Subject: **Response to On Hold Letter** for request for Section 401 Water Quality Certification Modification, Wilmington Bypass from north of US 74/76 in Brunswick County to US 421 in New Hanover County. DWQ Project No. 10-0867v.4. TIP R-2633B.

Reference: NCDOT Modification Request, dated April 3, 2013
NCDWQ On Hold Letter, dated April 19, 2013, received April 26, 2013

Subject: Request for Modification to Individual Section 404 and Section 401 Water Quality Certification for the Wilmington Bypass from north of US 74/76 in Brunswick County to US 421 in New Hanover County. Federal Aid Project Nos. NHF-0017 (96) and STM-0017(97), WBS No. 34491.2.3, TIP No. R-2633B, DWQ Project No. 10-0867v.4

rev. 5/2/13
Permit Drawing
Sheet 9 of 73

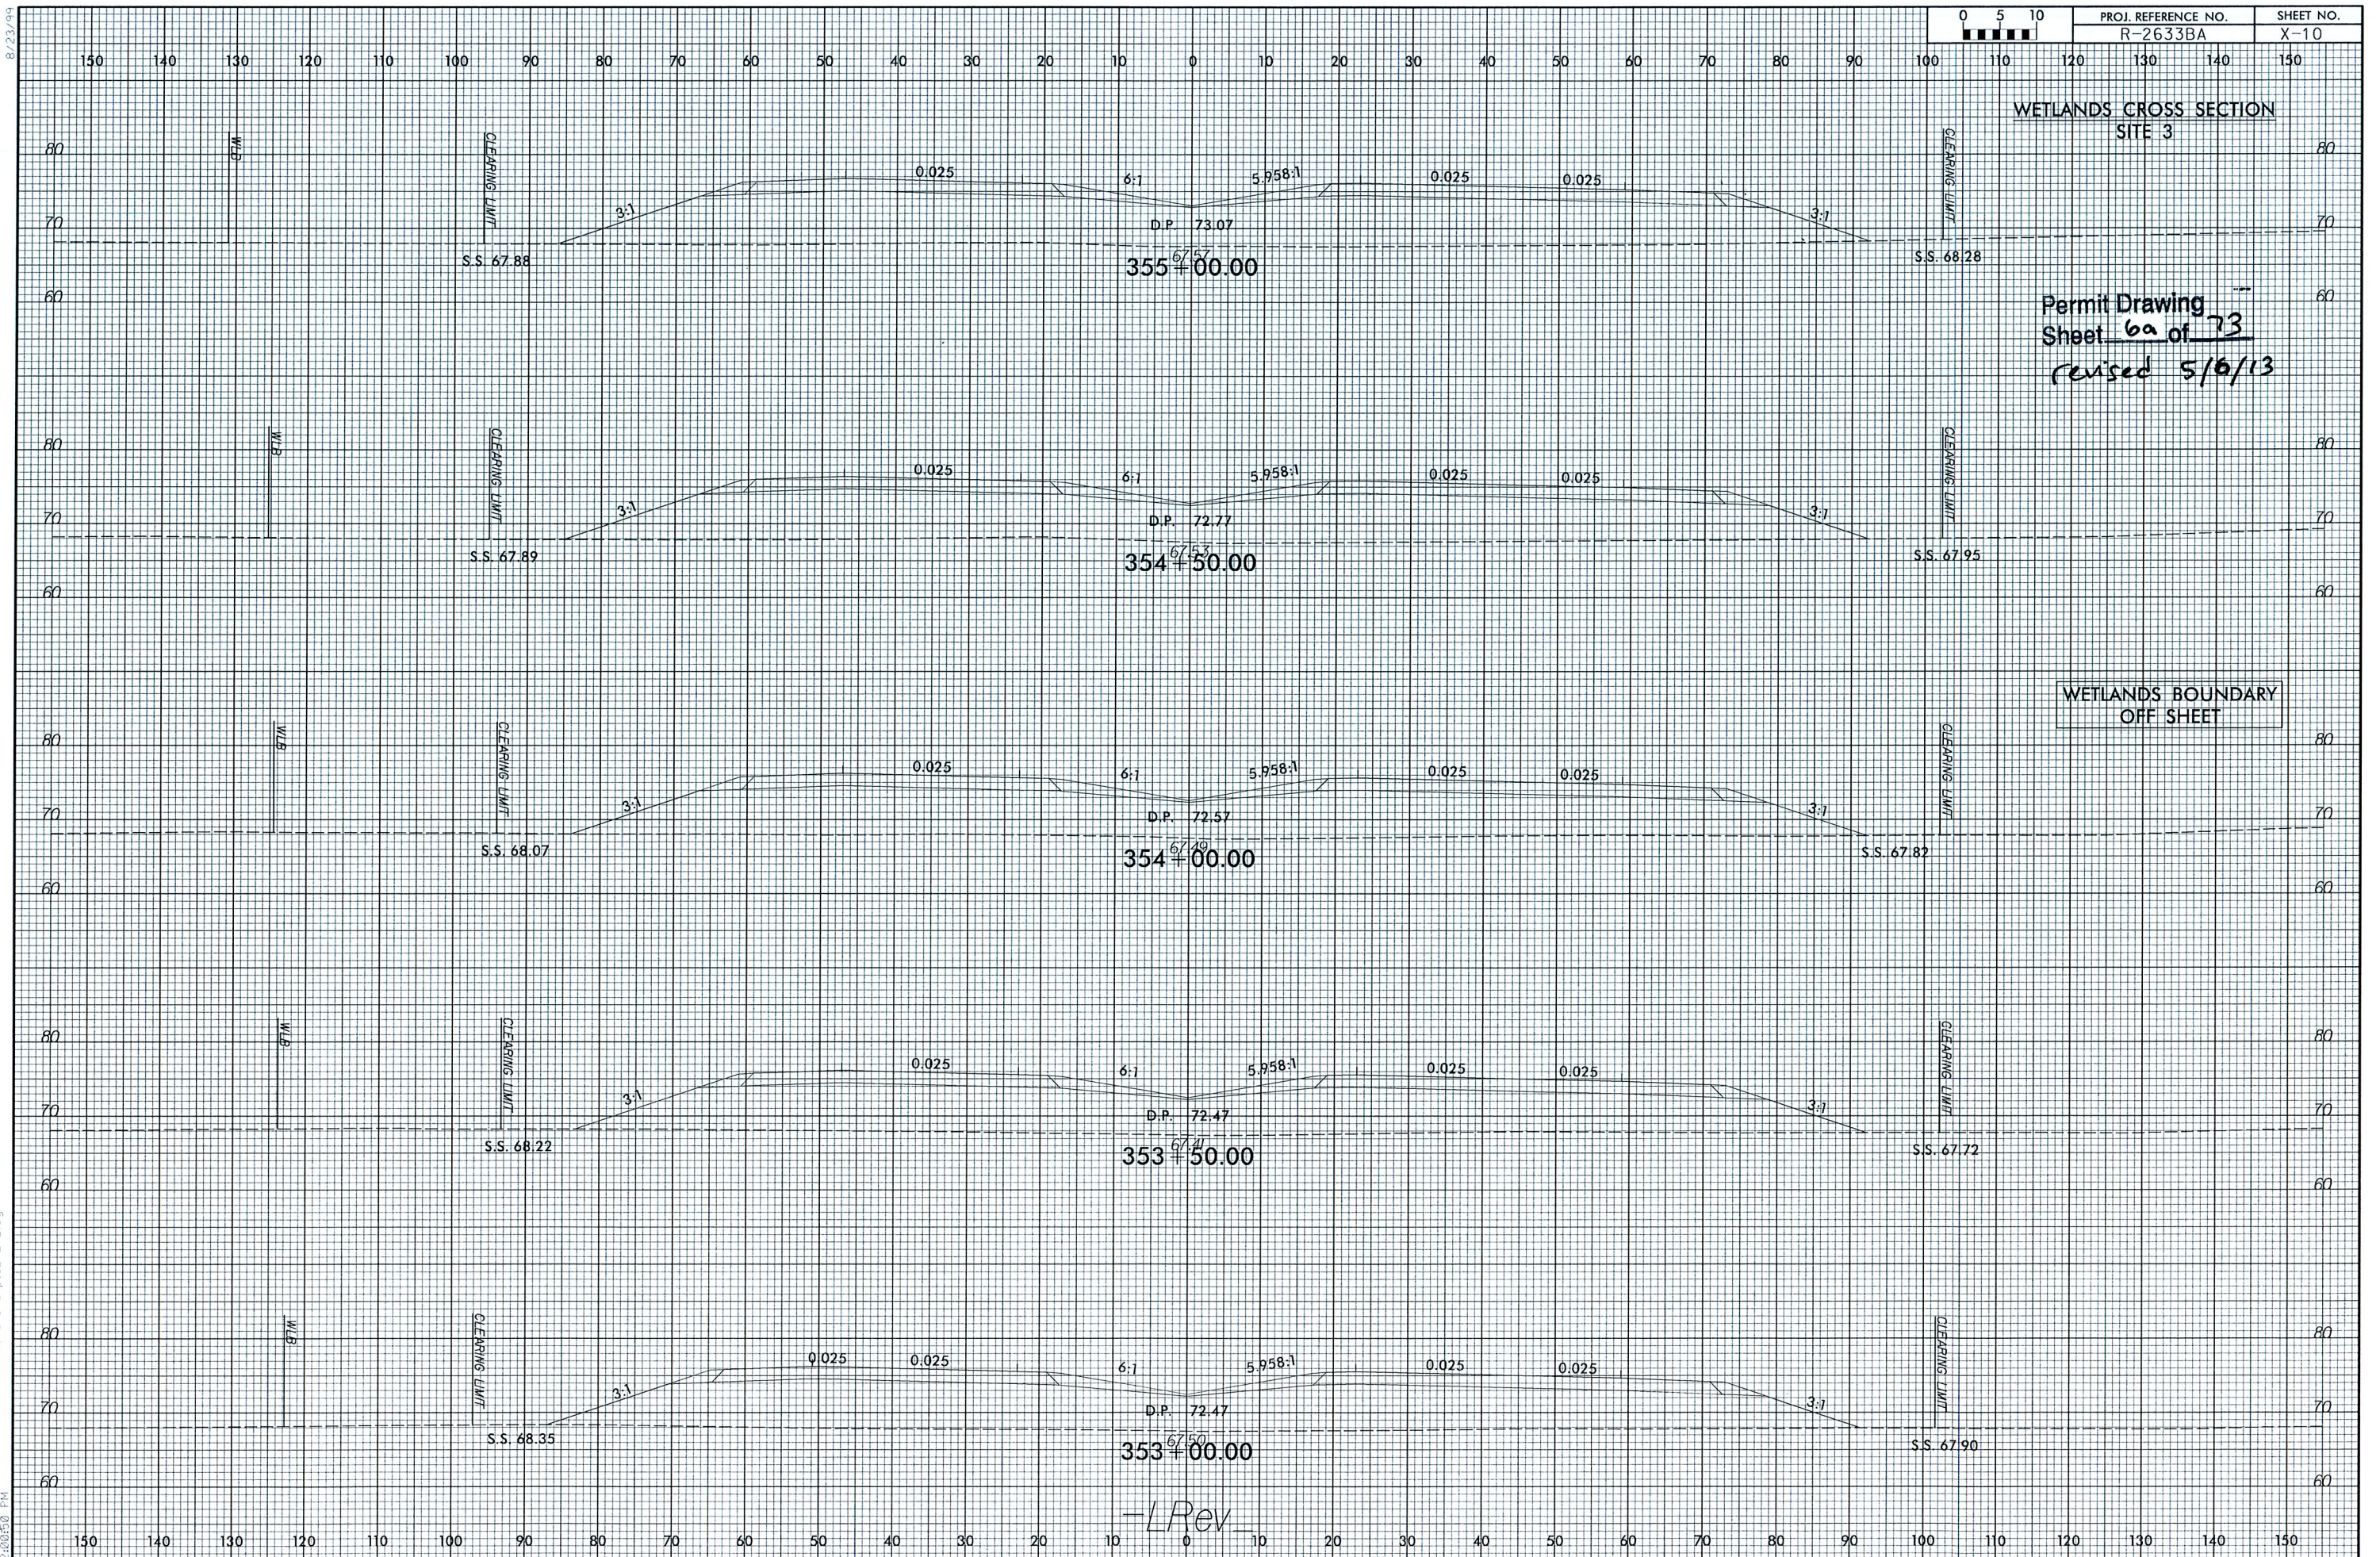
1. *Sites 3 & 5 – the cross section station numbers do not match the station numbers on the plan sheet. Also, the match line station numbers do not match the stations on the plan sheet. The station numbers in the impact summary and on the plan sheets run from 40+57 to 75+00 but the cross section numbers are listed as 345+00 to 375+00. Please change the cross section station and match line stations to coincide with the stations along the –L– line on the plan sheets.*

1. Sites 3 & 5 – the cross section station numbers do not match the station numbers on the plan sheet. Also, the match line station numbers do not coincide with the stations on the plan sheet. The station numbers in the impact summary and plan sheets run from Sta. 40+57 to 75+00 but the cross section numbers are listed as Sta. 345+00 to 375+00. Please change the cross section stations and match line stations to coincide with the stations along the -L- line on the plan sheets.

The station numbers on the impact summary sheet have been revised for sites 3 & 5. A slight change in the design for R-2633A resulted in the need for a geometric alignment shift for R-2633 BA (LREV) to tie the two sections together. Both sets of stations are correctly shown on the Permit Drawing Sheets 2, 3, 9 & 10 and an equality point is provided on Permit Drawing Sheets 9 & 10.
